2020 Corvette: GM TechLink: Removal of Corvette Z51 Spoiler

Removal of Corvette Z51 Spoiler

GM TechLink

Fig. 16

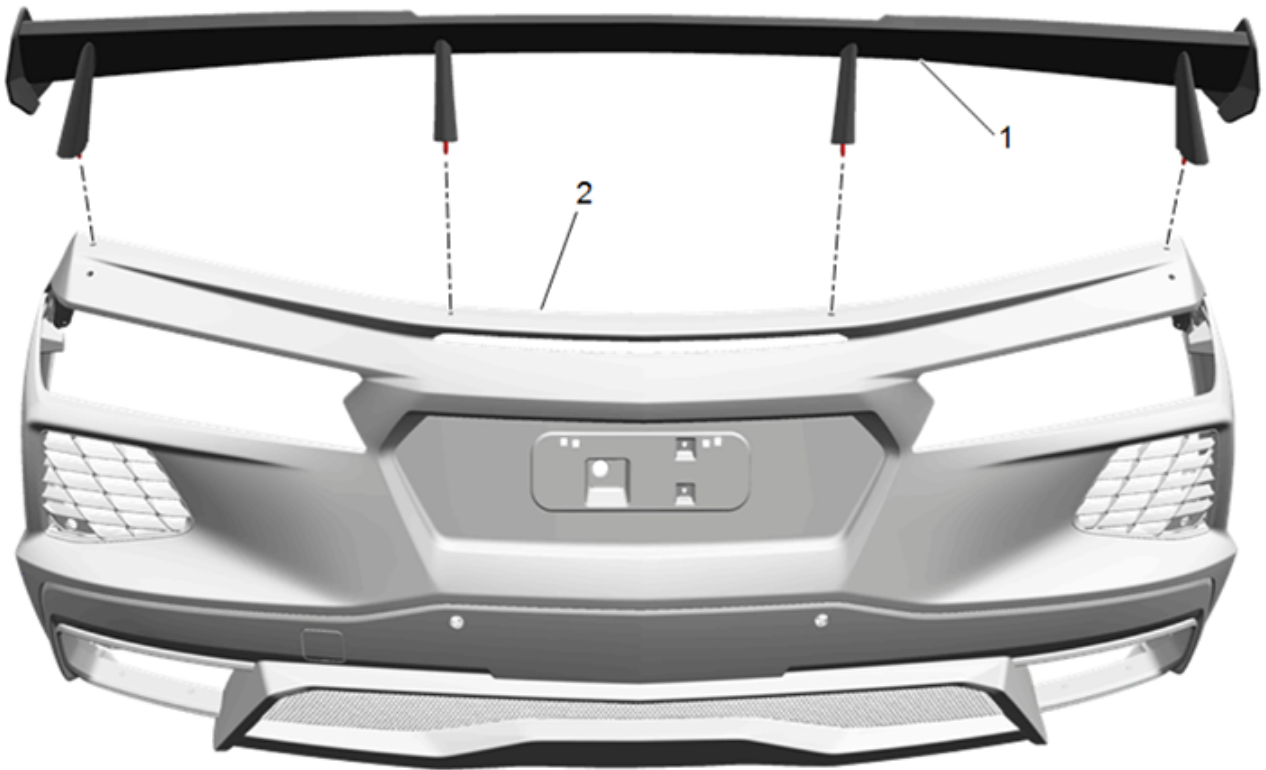
To remove the Z51 rear spoiler, it's recommended to use 50 lb. test monofilament fishing line. Position the line (Fig. 16, #1) between the spoiler and fascia and, with a sawing motion, move the fishing line through the two-way tape to remove the spoiler. Using the fishing line method will eliminate any possibility of damage to the painted fascia surface.

Do not use a heat gun, or attempt to pry the spoiler off the fascia with a plastic, metal or wood trim removal tool, in order to loosen the adhesive tape.

The installation instructions for Rear End Spoiler Package Installation (Fig. 17) in the Accessories Manual in the Service Information have been updated to eliminate the use of a heat gun to soften the two-way tape. Follow the updated installation instructions and do not use a heat gun during the removal process.
